Rockwell service bulletin

Service Bulletin No. SB-AG-12
13 July 1977

RIGHT WING RIB RIVET INSPECTION AND/OR RIB REPLACEMENT

MODELS AFFECTED: MODEL S-2R, SERIAL NO'S 5000 THRU 5084

Figure 1.

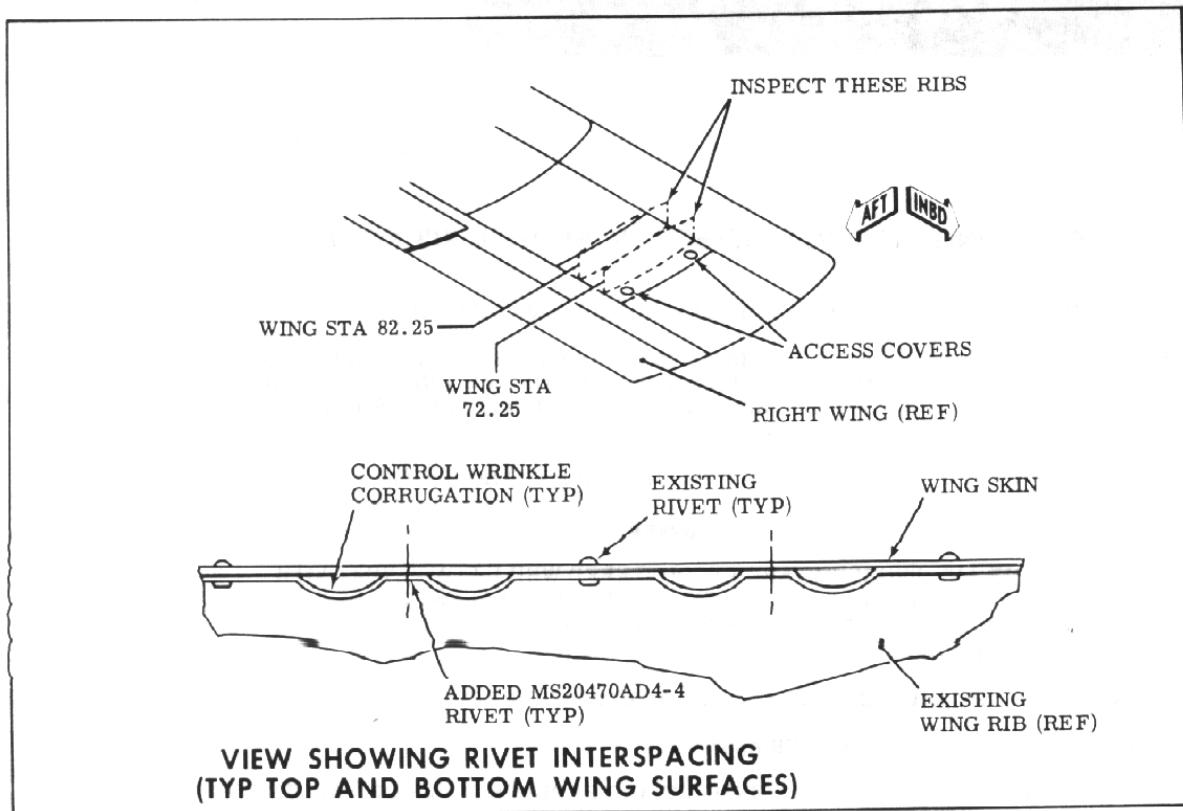
1. Remove two (2) lower wing access covers from right wing just outboard of wing fuel tank.
2. Inspect wing ribs at WS 72.25 and WS 82.25 for loose rivets and possible cracks in ribs.
3. If any cracks are found in either rib at WS 72.25 or WS 82.25, proceed to Part II.

4. If no cracks are found in ribs, proceed as follows:
 - a. Remove and loose rivets found during inspection and replace with MS20470AD4-4 rivet.

- b. Add interspaced MS20470AD4-4 rivets between existing rivets on upper and lower flanges of wing ribs (See Figure 1).

Added rivets to upper flange of wing ribs will have to be individually located to center on flat area between control wrinkle corrugations.

Figure 2.

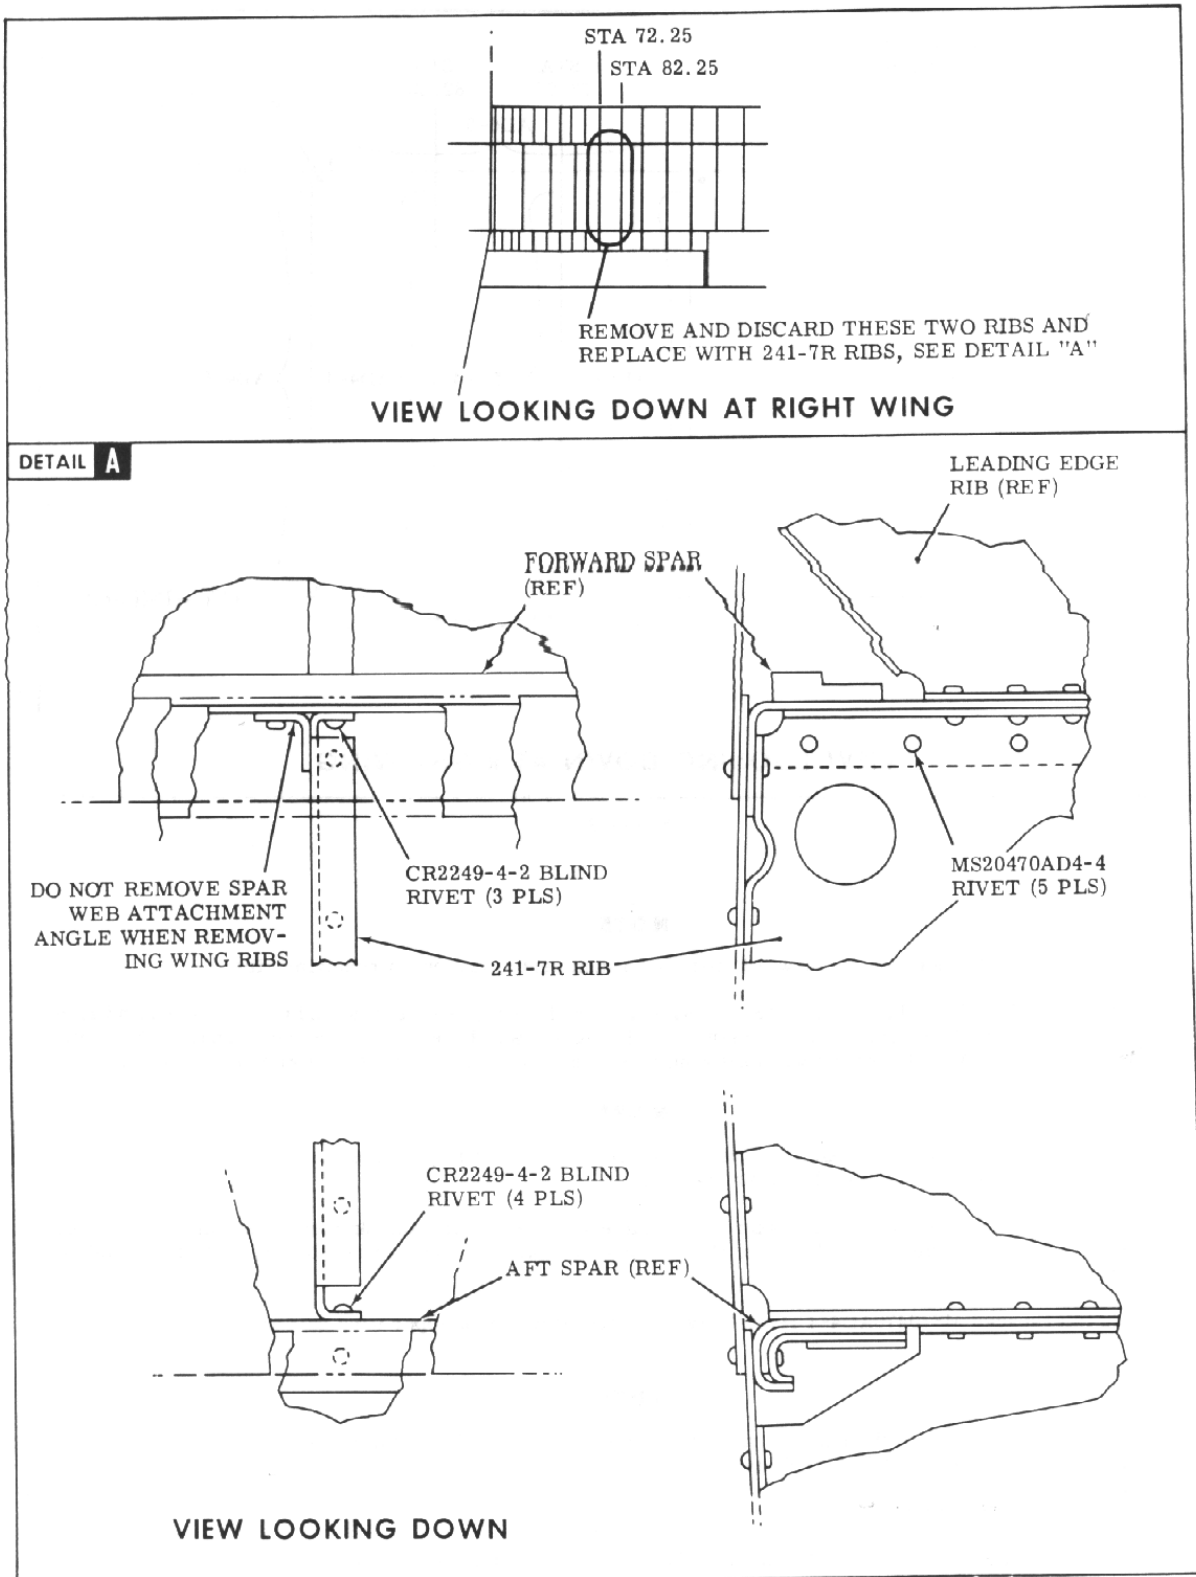
1. Defuel airplane as outlined in the Airplane Maintenance Manual, Section II.
2. Drill out rivets and remove upper center wing skin just outboard of right fuel tank (see Figure 2.).
3. Remove and discard existing wing ribs at WS 72.25 and WS 82.25 (see Figure 2.).

4. Install 241-7R rib (2 places) with MS20470AD4-4 rivets (lower flange of ribs) and CR2249-4-2 blind rivet (in forward and aft flanges of ribs) picking up existing holes in lower wing skin and in spars. Add interspaced MS20470AD4-4 rivet between existing rivets in lower skin and ribs (see Figures 2 and 3).

5. Install existing upper center wing skin and pickup existing holes in wing skin and seal wing skin in area of fuel tank as outlined in the Airplane Maintenance Manual, Section V under Resealing After Complete Skin Removal.
6. Add interspaced MS20470AD4-4 rivets between existing rivets in upper wing skin and new ribs (see Figures 2 and 3.).
